CONSUMERS POWER COMPANY
MIDLAND UNITS 1 AND 2
MASTER LIST OF COMMITMENTS TO NRC ON 10 CFR 50.54(f) RESPONSES
STATUS SORT: PARTS I AND 2

Bechtel Power Corporation
October 8, 1980

MASTER LIST OF COMMITMENTS TO NRC ON 10 CFR 50.54(f) RESPONSES

FIGURE 1

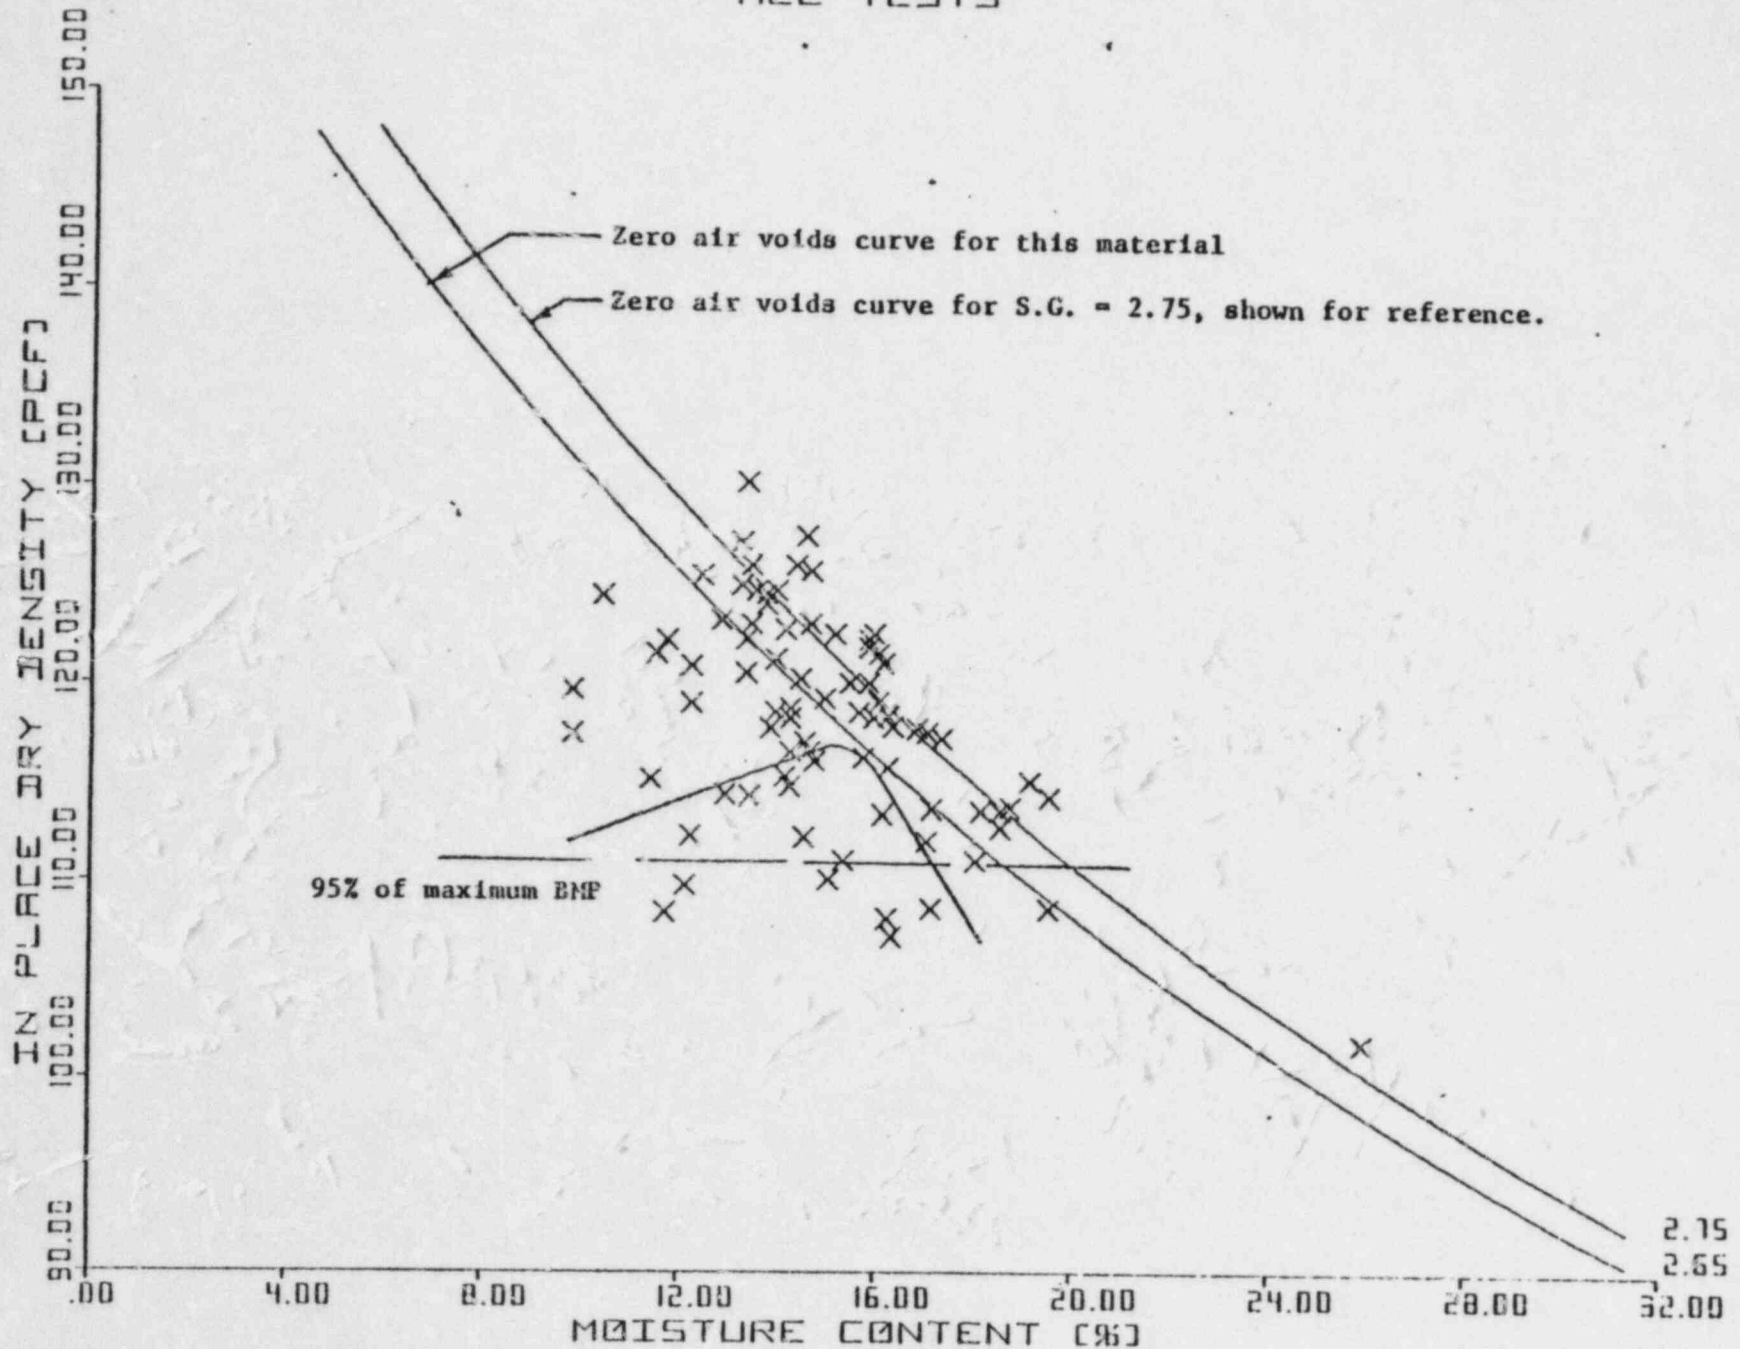
Soils cannot be more than 100 percent saturated; therefore, all field density test data points, when plotted as dry density versus moisture content, must be below the zero air voids curve as defined by the specific gravity of the material. Specifications do not require examination of the zero air voids curve, but it is considered common practice relative to compaction plots. There are numerous cases in the U. S. Testing Company data where points plot above the zero air voids curve. Figure 1 attached shows a typical laboratory compaction test curve with field test results plotted on it. Many of the field test results are to determine percent compaction plot above the zero air voids curve. Provided the specific gravity is correct this is not possible so that all such points must represent erroneous data.

Also, referring to Figure 1 it would appear that soil density varied widely. Specifications called for compactive effort results as defined by ASTM D 1557 which is 56,255 ft-lb/ft³ energy. This was modified to a laboratory test compactive effort of about 20,000 ft-lbs/ft³ energy, often referred to as Bechtel Modified Proctor (BMP). Laboratory compaction test curves should be related to the same effort as that called for in the field for use in comparing with field density tests to determine percent compaction. According to plots of field data shown on Figure 1, density varied from about 108 lb/ft³ to about 130 lb/ft³. It is doubtful that the soil classification or other properties would be similar for such a wide variation in density. It is noted that 100 percent of modified Proctor (ASTM D 1557) which is difficult to obtain, is rated at 56,255 ft-lb/ft³ energy. The curve plotted on Figure 1 is at about 20,000 ft-lb/ft³ energy. For comparative purposes it was determined by U. S. Testing in 1974 that 100 percent of specified effort (20,000 ft-lb/ft³) is approximately equal to 95 percent of the maximum density as determined by ASTM D 1557 (56,255 ft-lb/ft³) Reference Figure 8.

band of specific gravity values represented in the Bechtel report figure 1 results in a 49 percent reduction of theoretically impossible results. The remainder of these test points falling above zero-voids line will be discussed in Section 6. However, specific gravity values from 2.57 to 2.82 for soil fractions are documented for material on this project.

FIGURE 3

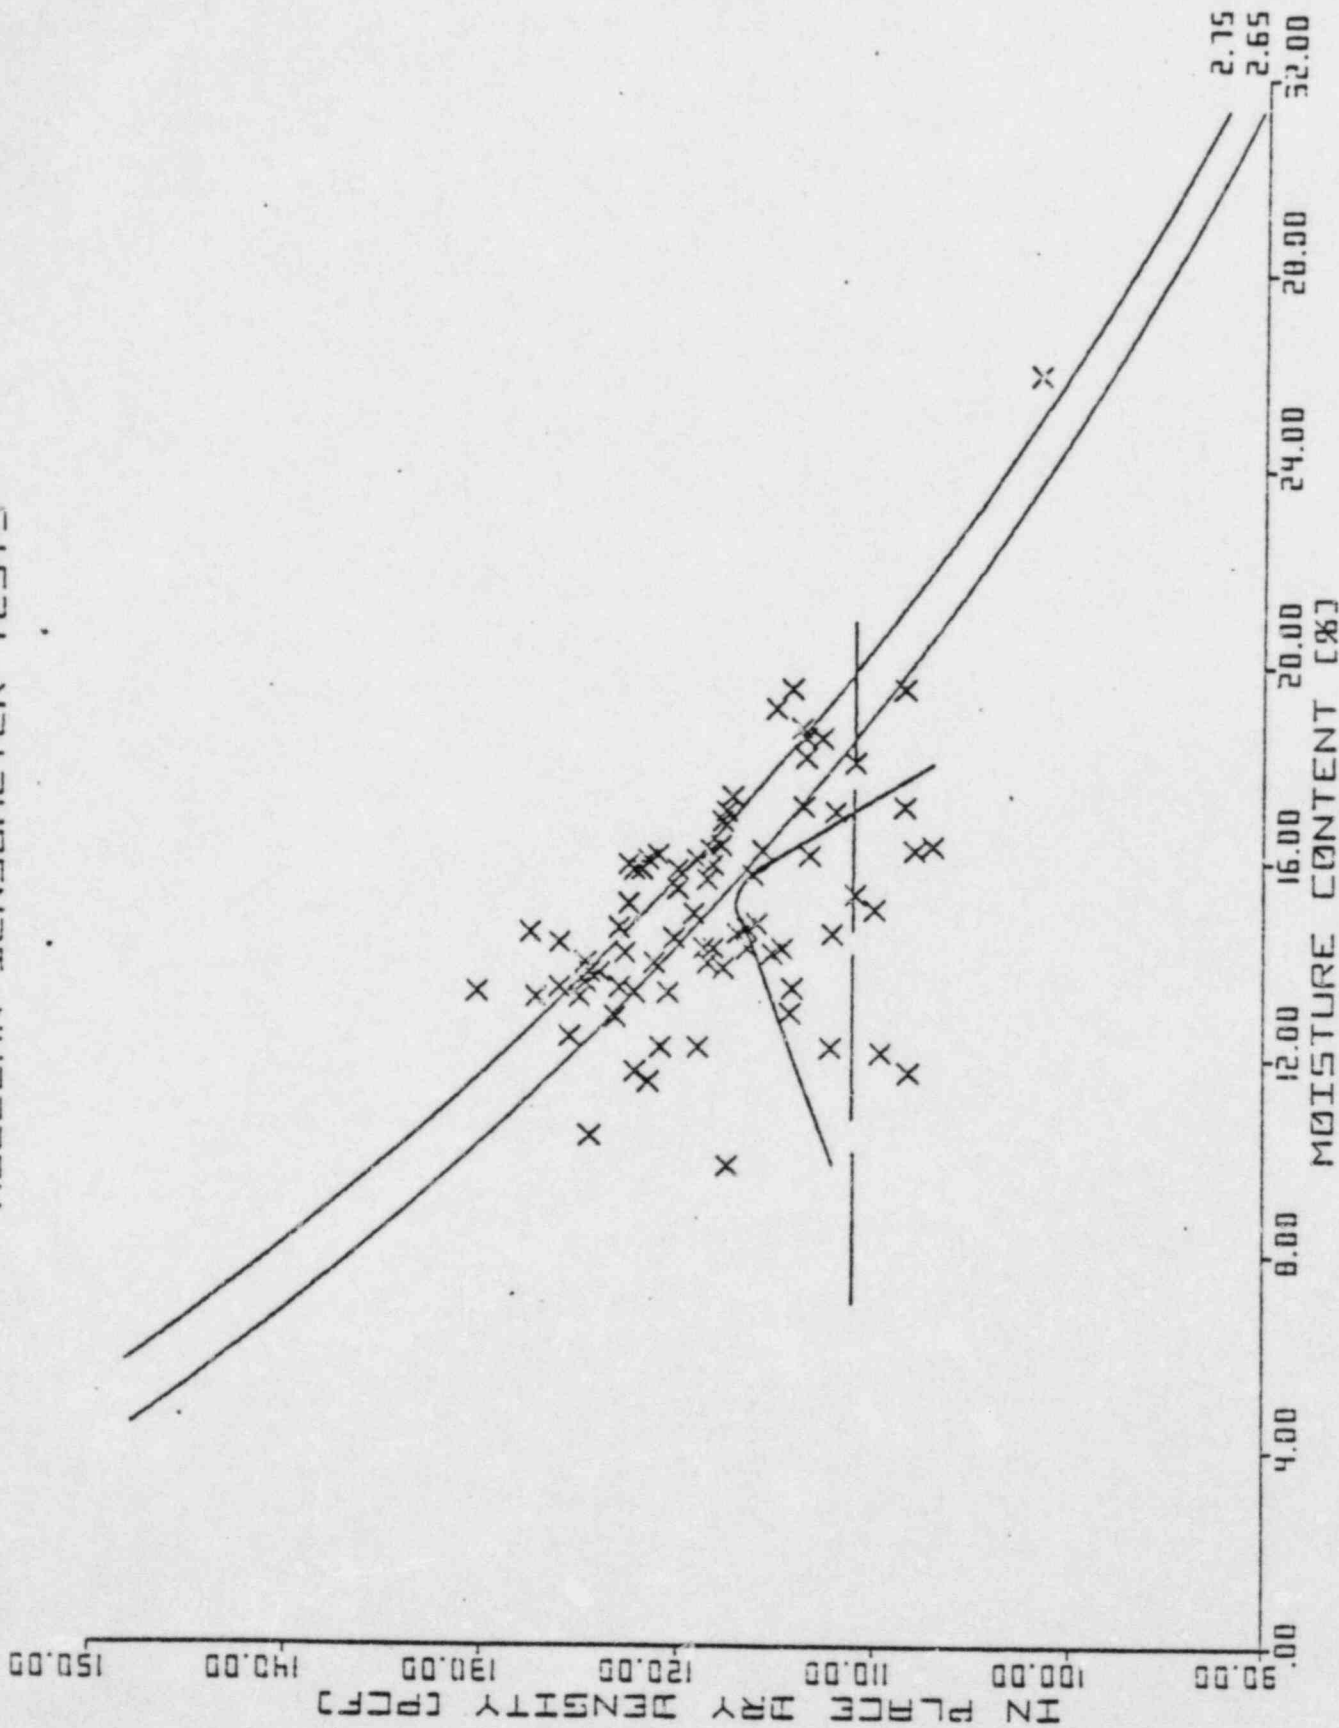
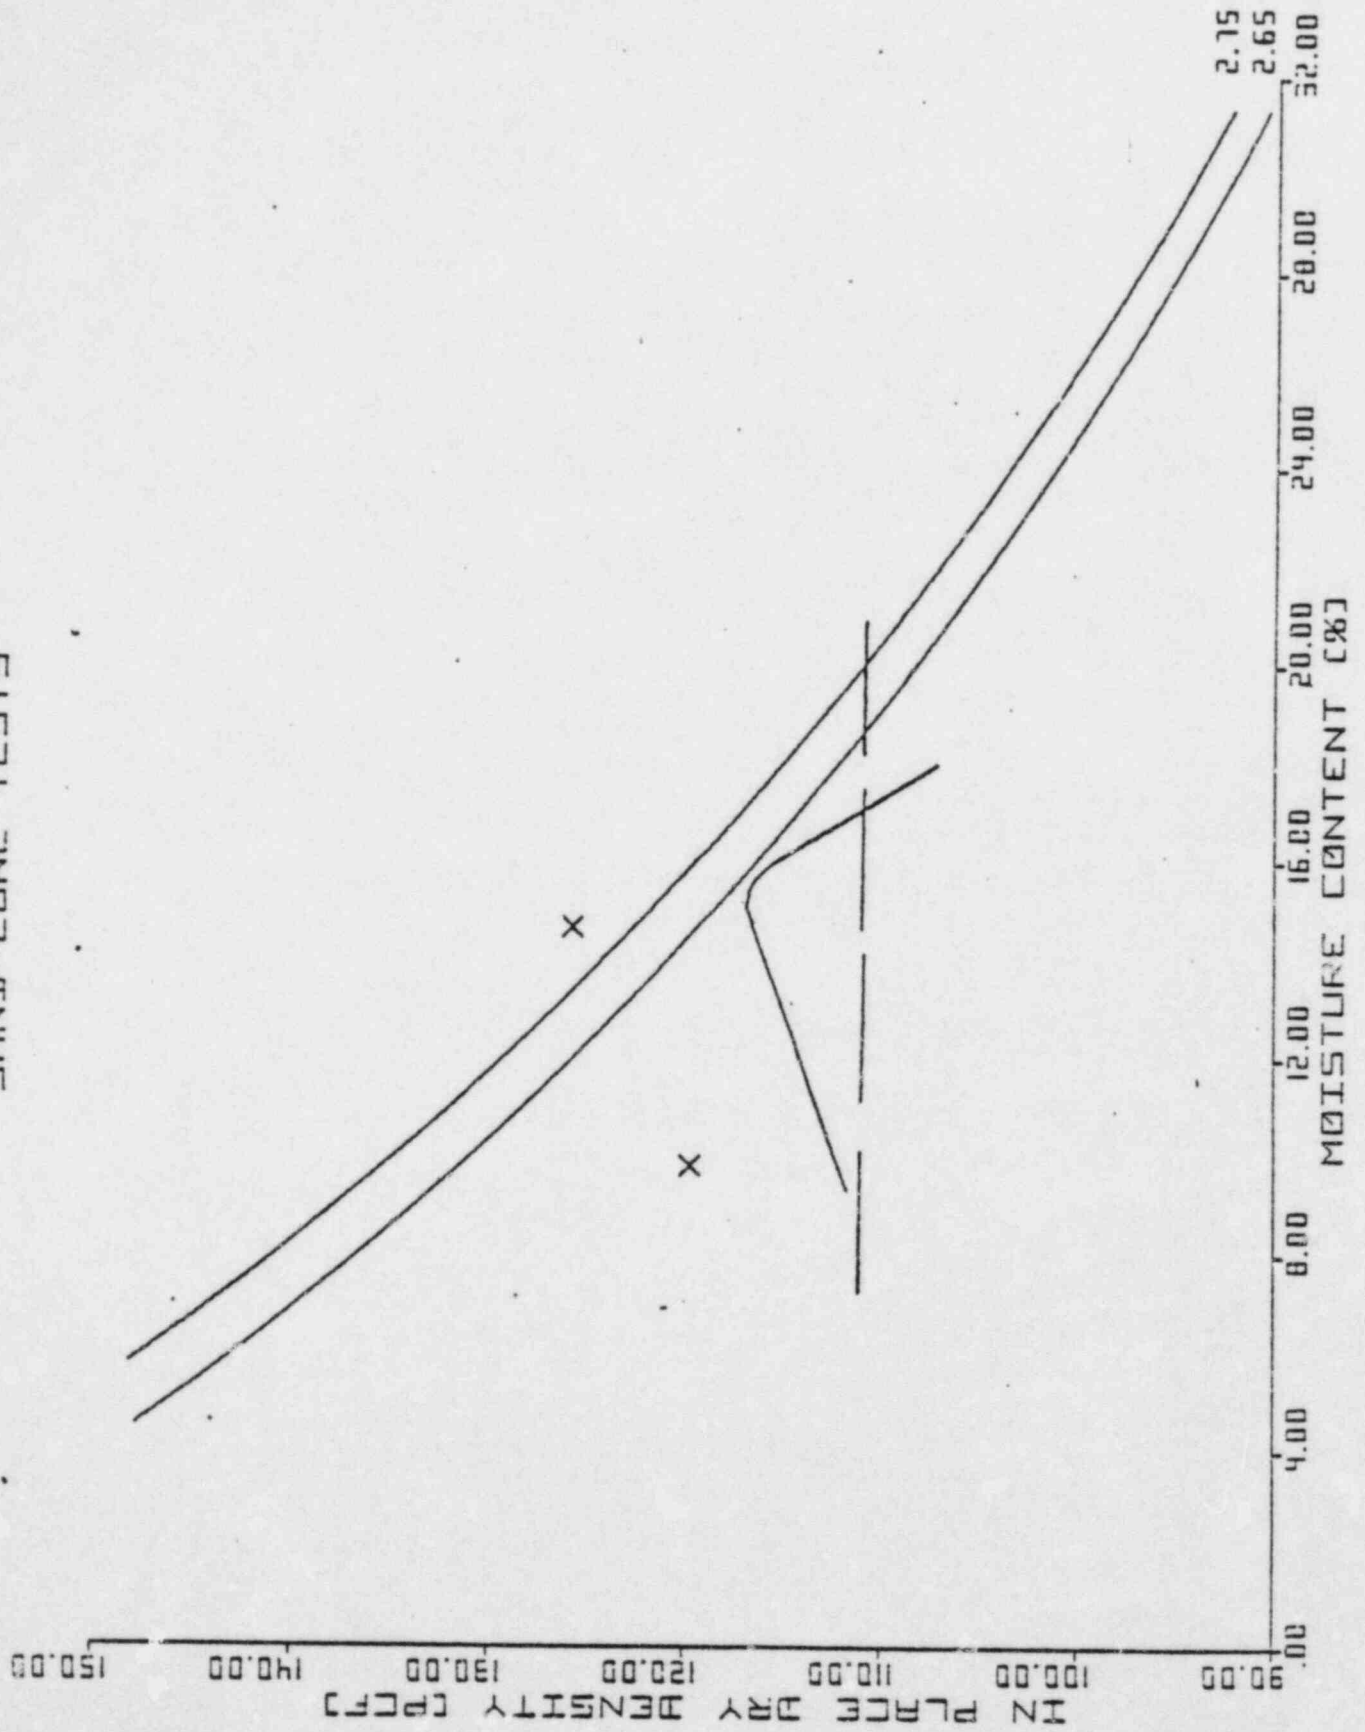
Plots of field data for compaction test BMP 278 are shown on Figures 1 through 6. The title of each figure gives the assumptions made in plotting data for the figure. In comparing figures 3 and 4 it is seen that a majority of field tests were made using the nuclear device. The two test results shown on Figure 4 for the sand cone method indicates one test result on each side of the zero air voids curve. The one falling above the zero air voids curve (shown on Figure 4) is designated by U. S. Testing Company as the only passing sand cone test (shown on Figure 6).

FIGURE 7-A-

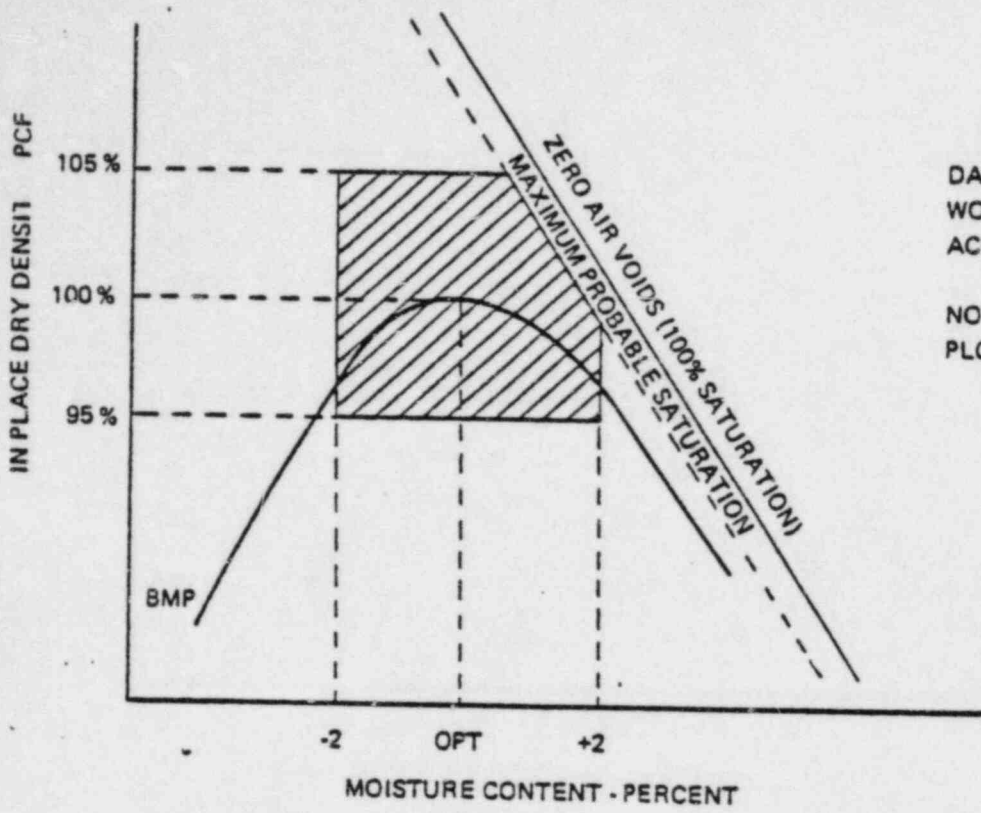
For a field test result to be valid as well as "Passing" it must fall within a well defined area on the plot containing the laboratory compaction curve. This area or window of acceptability is shown for a hypothetical compaction curve on Figure 7a that would meet requirements of Specification 7220-C-210. It is defined by horizontal lines at 95 percent and 105 percent of specified density, vertical lines through ± 2 percent of optimum moisture content, and a line parallel to the zero voids line indicating saturation about half way between the compaction curve and 100 percent saturation (zero air voids curve). The practical upper limit of 105 percent of specified density is not defined in the specifications. It was arbitrarily chosen as numbers greater than this give increasingly invalid comparisons between field test results and the specified laboratory compaction test curve. Therefore, if all data points fall within the defined window there would be no reason to assume that they are wrong. However, when many data points fall outside the designated area there is something wrong with the information and then all data points become suspect. A review of all data indicates that about 25 percent of the cohesive soil test results fall within this area.

FIGURE 7-B-

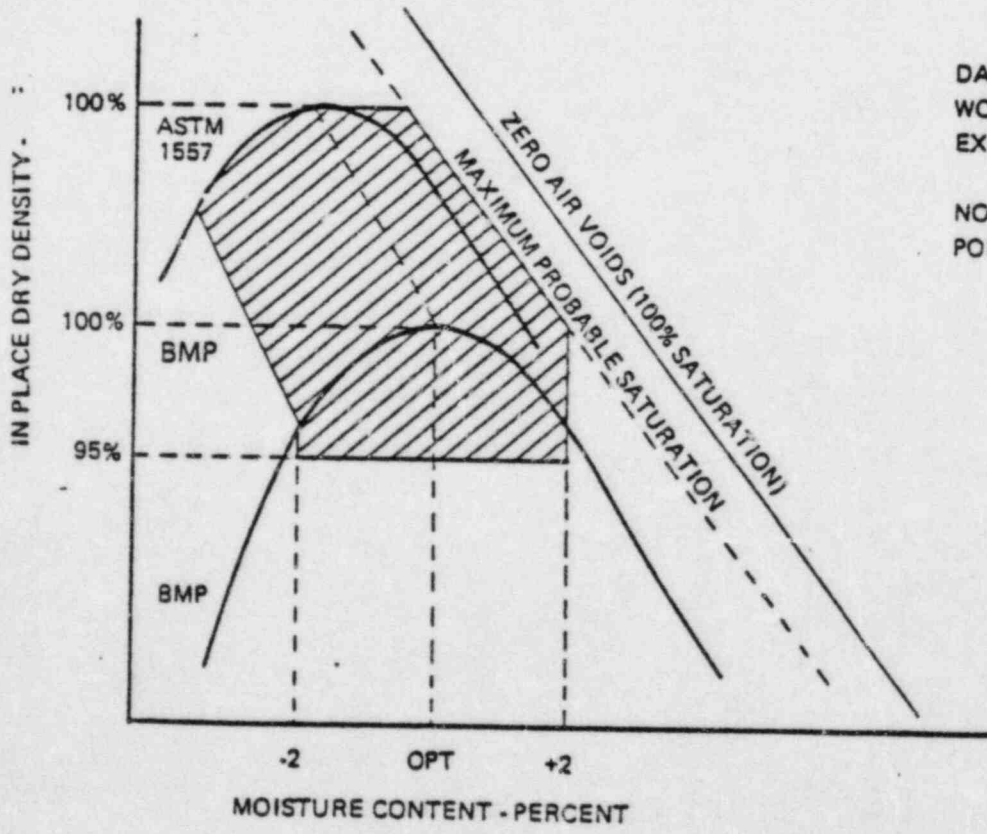
Figure 7B shows an area where field test results would be acceptable, in theory even though not in strict accordance with the specifications. Figure 7B was arrived at by expanding Figure 7a to include test results up to a compactive effort related to ASTM D 1557 (56,255 ft-lb/ft³) which is considered to be a practical upper limit. About 40 percent of all cohesive soil test results would plot in this area.
